CITY OF MONROE
Inter-Office Correspondence

DATE: June 16, 2026
RE: Information Packet for June 16, 2026, Planning Commission Meeting at 6:00 p.m.

I. Case No. 2026-6-4—PUBLIC HEARING, Consideration of a Site Plan and Conditional Use Permit for the Monroe Municipal Services Center

MONROE MUNICIPAL SERVICES CENTER
200 CLARK BLVD
MONROE, OH 45050
COVER SHEET

PRINCIPAL BUILDING ELEVATIONS

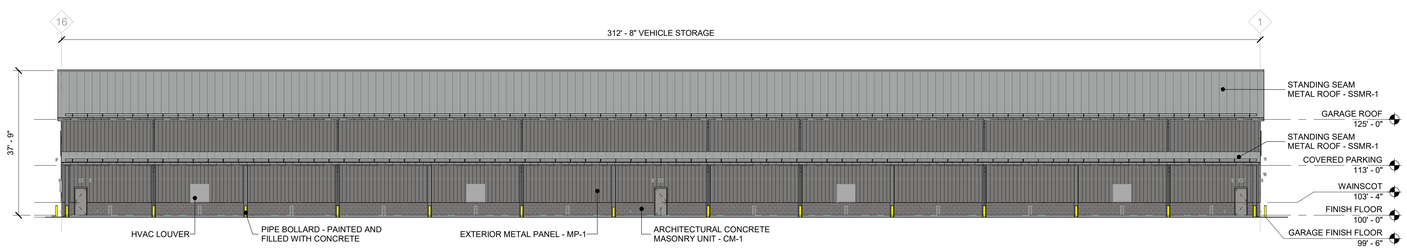
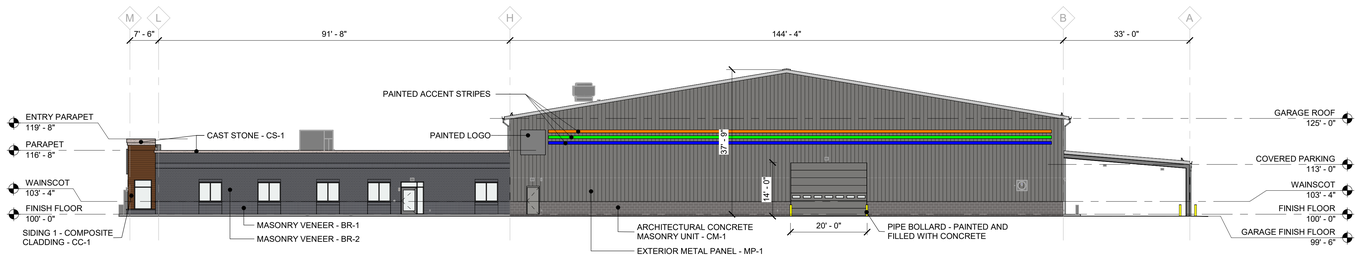
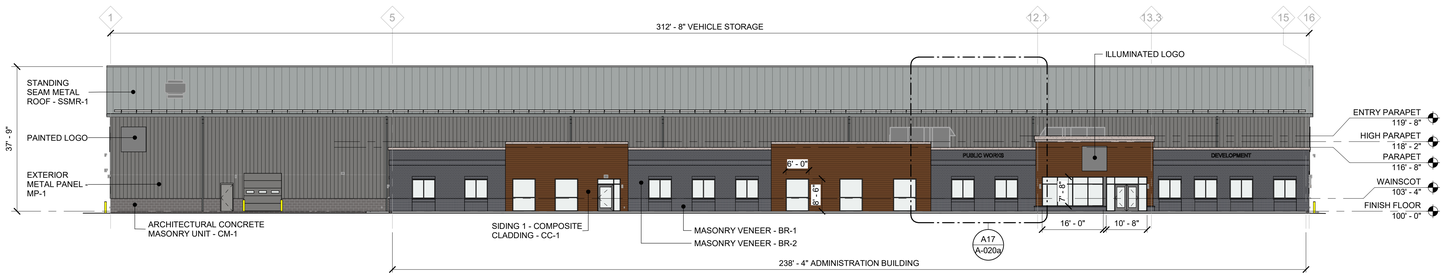
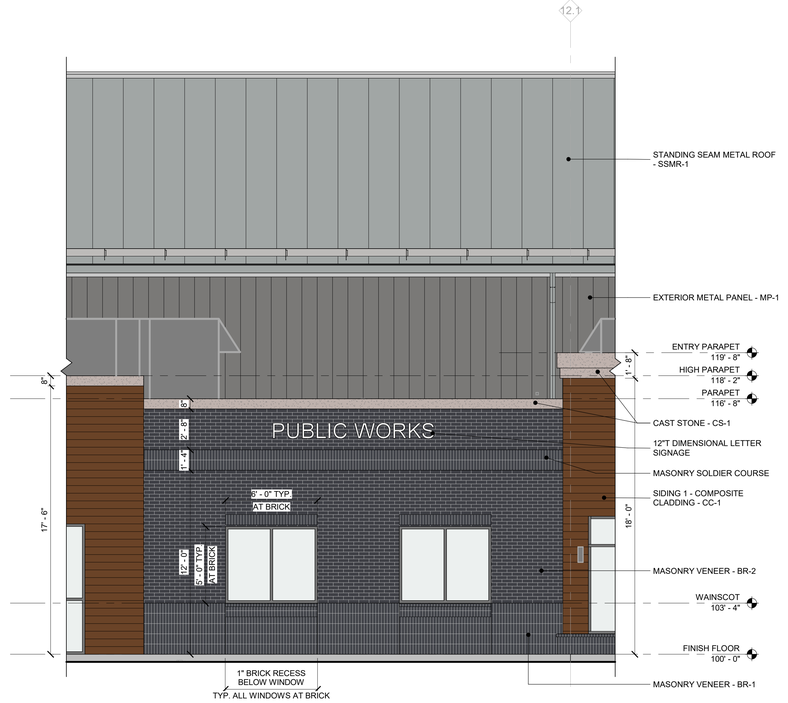
- **Architectural**
    - Base, Body, Cap Design Elements.
        - The applicant must show the Base, Body, Cap percentages on the elevations to ensure compliance.

- Revise each elevation to show the base, body, and cap percentages to ensure compliance.
    - All landscaping must meet all minimum species and size requirements and be detailed appropriately on the plan.

1 E-002 **SITE PHOTOMETRICS**
1" = 30'-0"

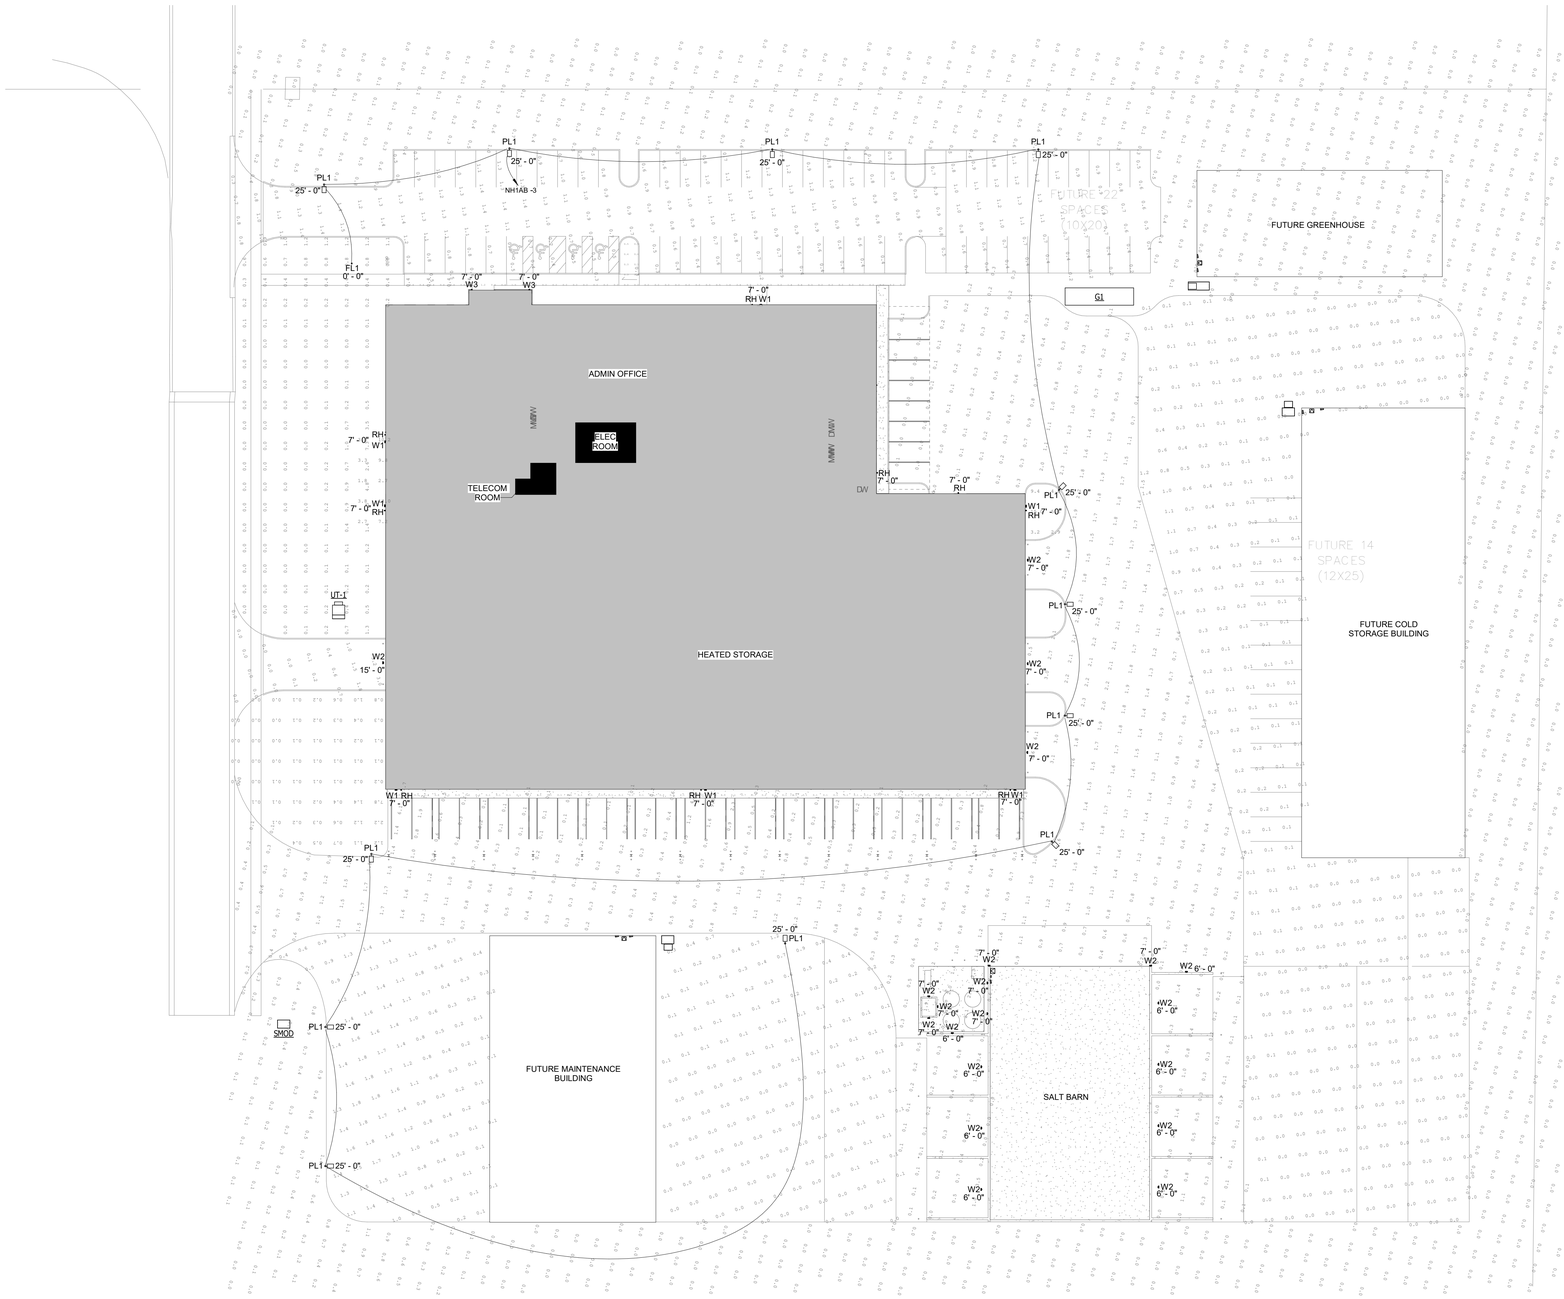
- **Photometric**
    - Illumination is required consistently across the site and shall be designed so as not to create dark spots that may create safety issues in such areas as vehicular use areas and connecting pedestrian paths.
        - The photometric plan is missing the southern property line. Please revise.

- Revise the photometric plan to show the southern property line.
    - Show a line-of-sight diagram to ensure proper screening for rooftop equipment.
